R03GZ

Driver's Platform Rear Flange Bolts

MODELS AFFECTED: 1999 to 2004 All American Rear Engine (A3RE) and 1991 to 2004 TC/2000 Rear Engine (TCRE, T2RE) School Buses

RO3GZ
CAMPAIGN
RECALL

Bolt Locations

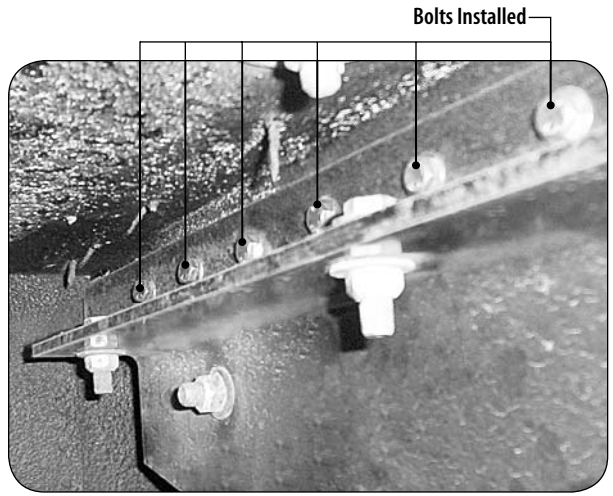
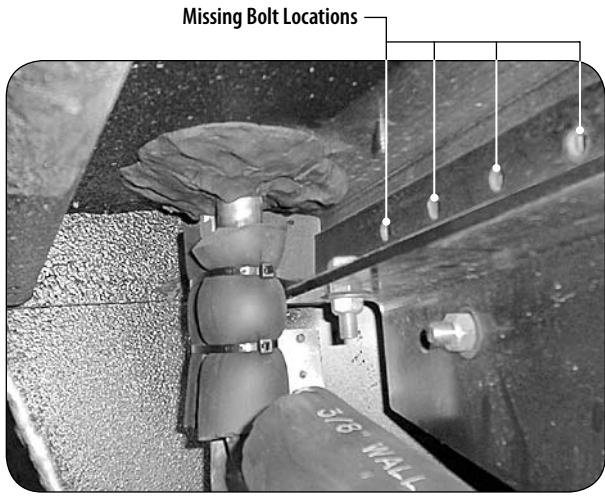
Bolts that attach the driver's platform rear flange to the body floor structure may not have been installed.

4 Inspect the floor joint between the Driver's Platform, the No. 2 Floor Assembly and the Front Floor Assembly for a total of fourteen (14) bolts. Twelve (12) bolts connect the Driver's Platform and the No. 2 Floor Panel Assembly. The remaining two (2) bolts connect the Front Floor Assembly and the No. 2 Floor Panel Assembly and can be accessed from between the frame rails. See "Bolt Locations" illustration on page 2.

5 If any bolts are missing, install bolts, lock washers, and nuts. Torque all bolts to 10 to 15 ft-lbs.

6 If the holes in the flanges on the floor panels do not line up, backdrill 11/32 (.344) diameter holes using existing holes as guides. Using a 90 degree angle drill is recommended.

CAUTION Use a backing plate between the heater hoses and the body flange to prevent damage to heater pipes and hoses.
